**Model:** SR6001, SR7001 SR8001

**Subject:** The thermal sensor is sometimes activated, which shuts down the unit putting the unit into standby.\*

Fig.1

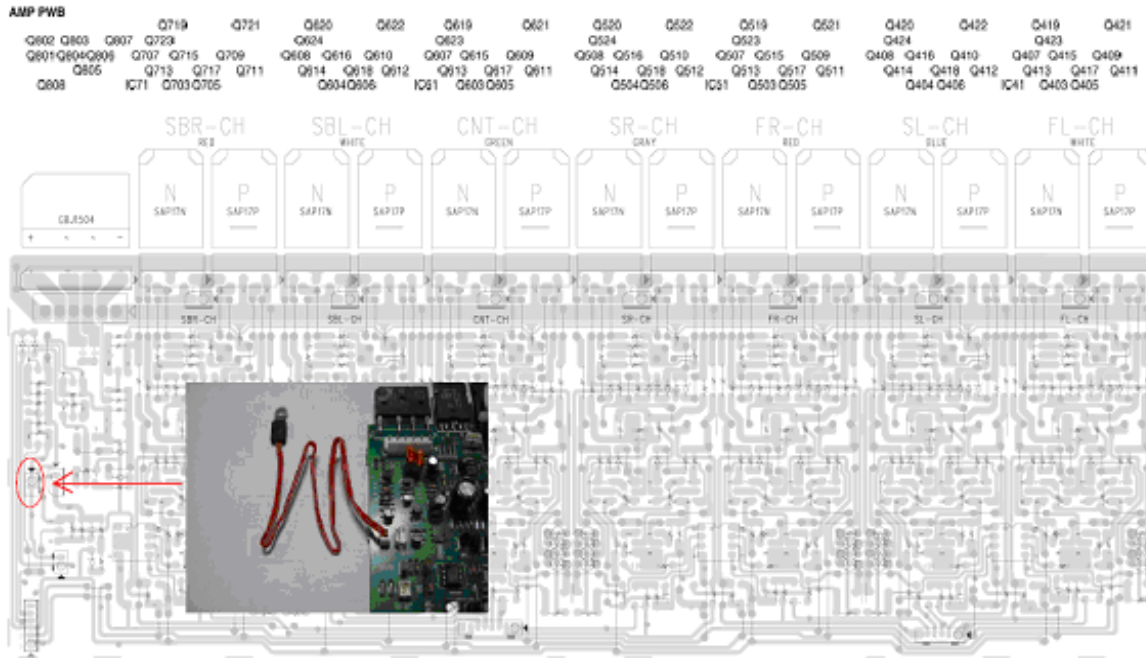
2. Cut the white plastic connector (CN81) off the new Heat Sensor then strip ¼ inch (approx.) of insulation from the end of the lead and tin each end of the lead wire. (Fig. 1)

Fig. 3

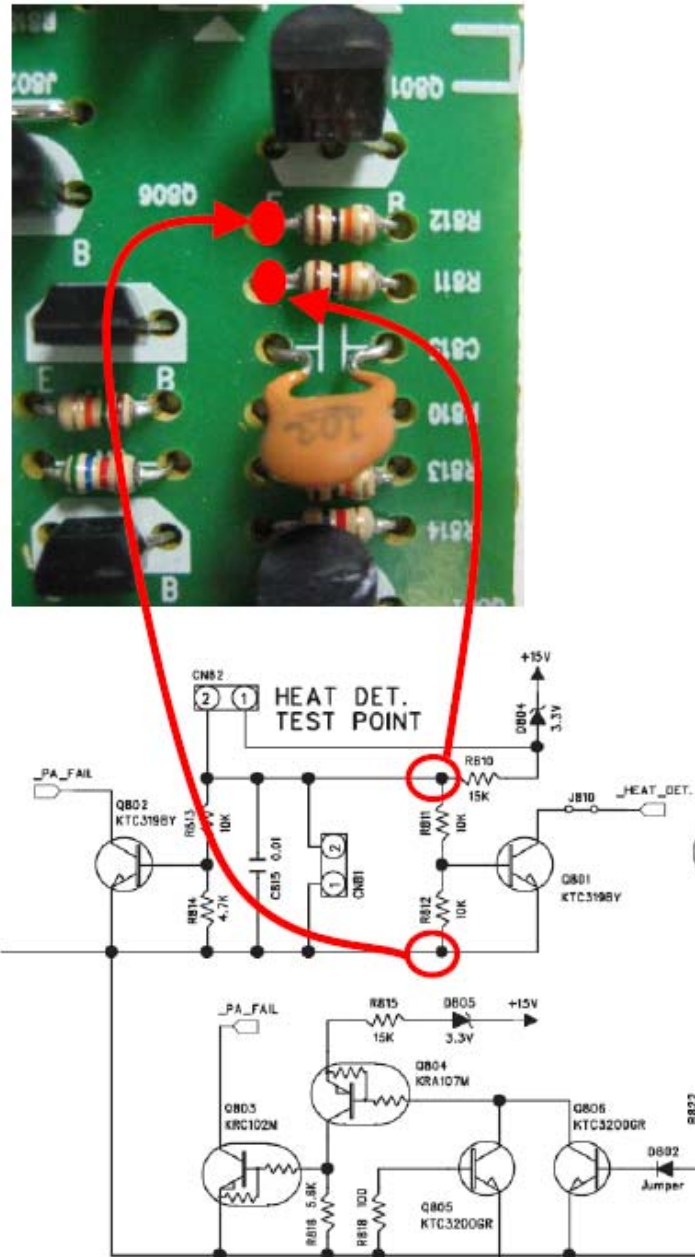
3. Solder the stripped ends of the lead wires to resistors R811 and R812 as shown below.

**Note:** The Heat Sensor has no polarity however, be certain to connect the sensor to the side of each resistor that corresponds (electrically) to connector CN81's pins 1 & 2. Do not solder the leads to the side of resistors R811 and R812 that are closest to the base of transistor Q801. See Figure 3 for details.

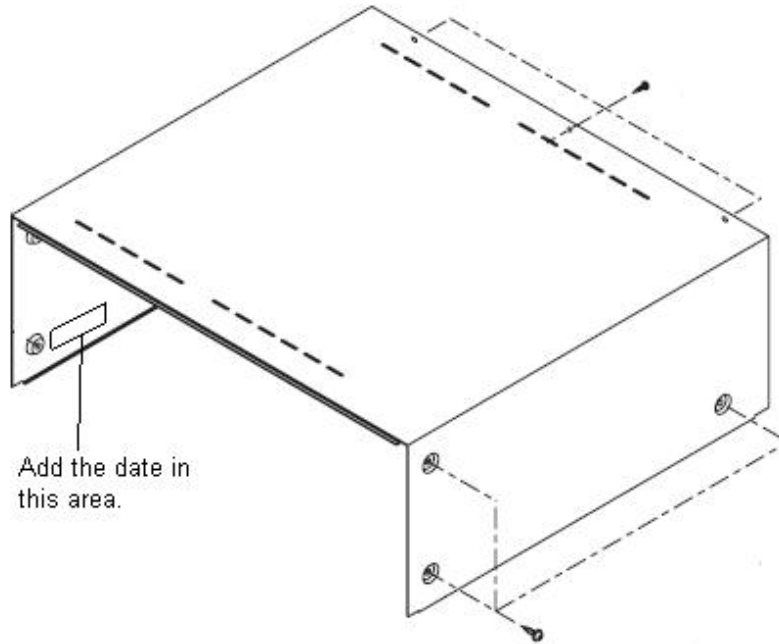
4. Fix the soldered wire ends to the resistors using Sony® bond SC608Z or Dow Corning® SE 9188 RTV high temperature RTV.
